Flo Consulting Letter dated 30th June 2025. To which the David Uncle from Herts County Council LLFA has no technical response.

SECTION E-E THROUGH OVERLAND FLOW CHANNEL
ADJACENT TO CARRIAGEWAY
SCALE 1:100

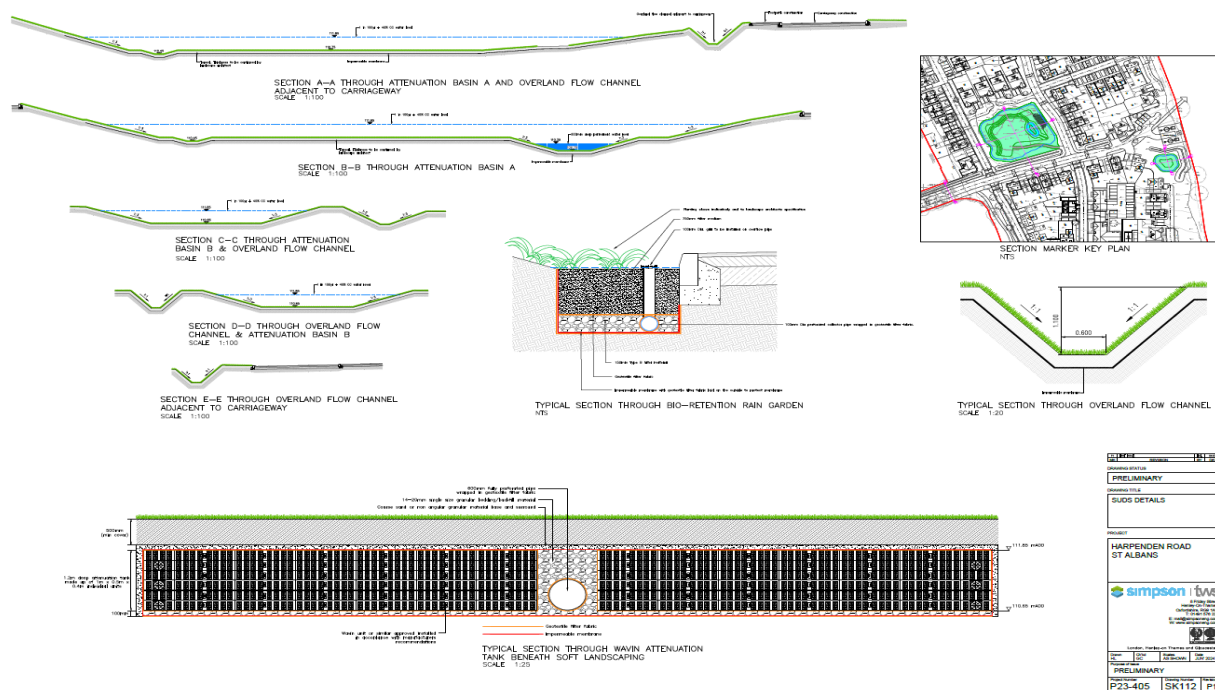
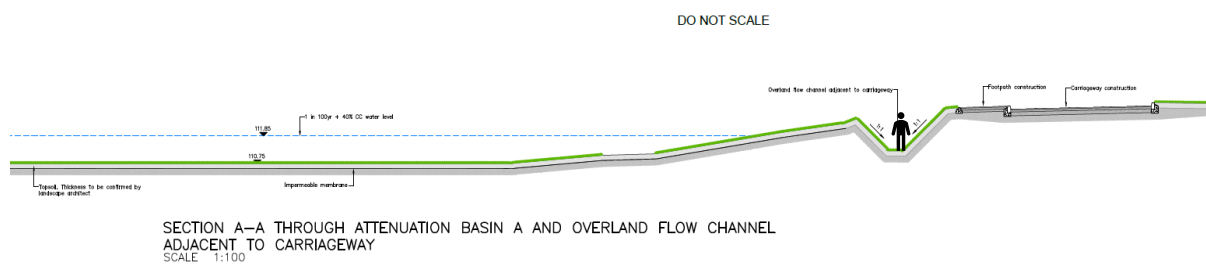
It is extremely difficult to maintain vegetation / grass on a 1 in 1 gradient, as the maintenance machines / vehicles cannot access the steep slopes to cut back the vegetation / grass growth. Subsequently the swale width and surface water capacity will be reduced as the vegetation / grass grows, leading to reduction in flows and increasing risk of potential flooding.

Safe working depths in trenches (a swale in this instance) shouldn't exceed 1.20m. As the swale is up to 1.697m deep, safe access and egress cannot be made without the use of aids such as access ladders.

The use of ladders and other aids for access and egress may be difficult to achieve with the vegetation / grass growth along the swale. Access aids shouldn't be relied upon in areas which are subjected to high water levels and velocities, where quick egress is required in an unexpected storm event.

1.697m = 5 feet 7 inches

Average height of men in UK = 5 feet 9 inches

Average height of women in UK = 5 feet 6 inches

Section E-E is across the access road, which is not a suitable width to accommodate a swale designed to minimum regulation standards.
